RELEASE NOTES

Trimble® NetR9™ Infrastructure GNSS Series Receivers

This is the May 2013 release (Revision A) of the *Infrastructure GNSS Receivers Release Notes*. It applies to version 4.80 of the receiver firmware.

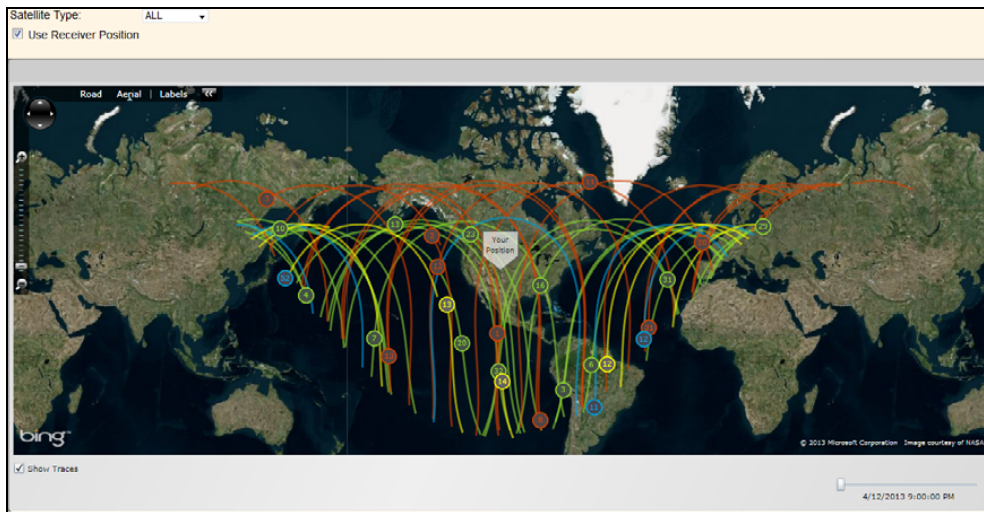
- Improved handling of HTTPS SSL certificates.
- Improved resilience against FTP Server attacks.
- Bandwidth limiting option now implemented for NTRIP Caster and NTRIP Servers.
- DNS queries via PPP connections now use the PPP IP address.
- Improved handling of DNS entries when switching networks.
- Resolves issue where TCP port connections cannot be reestablished after a UDP broadcast port was configured.
- NTRIP Caster and NTRIP Server mountpoints no longer allow for the following characters:

;	@	\$
/	&	'
?	=	(space)
:	+

If any of these characters is entered it is replaced automatically with an underscore '_'.

- Sky Plot

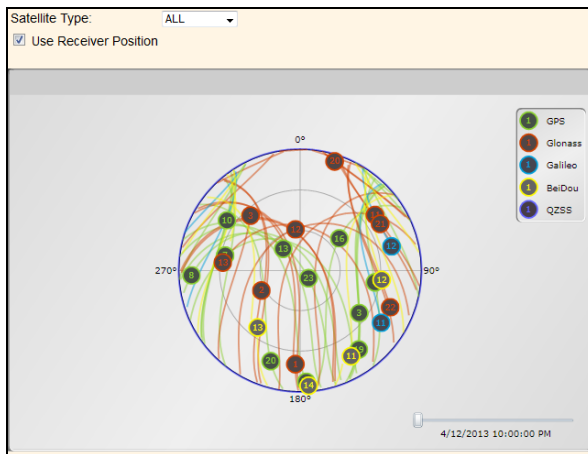
- New Web Interface menu, *Web Services*, that allows for the following selections:
 - Satellites - Map View
